RFP 23-007

Goodfellow Air Force Base DEAAG Construction – North & South Fob Expansion

ADDENDUM NO 1:

Notice to Vendors: Clarification Request

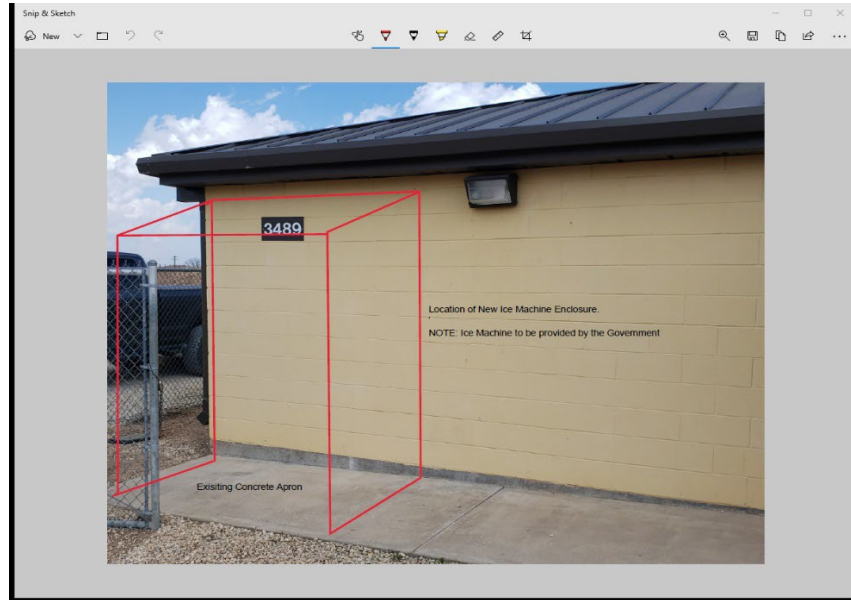
Is there an existing walk or pad for the shed?

GAFB CE Response: Yes, there is an existing concrete apron at the preferred location for the enclosure.
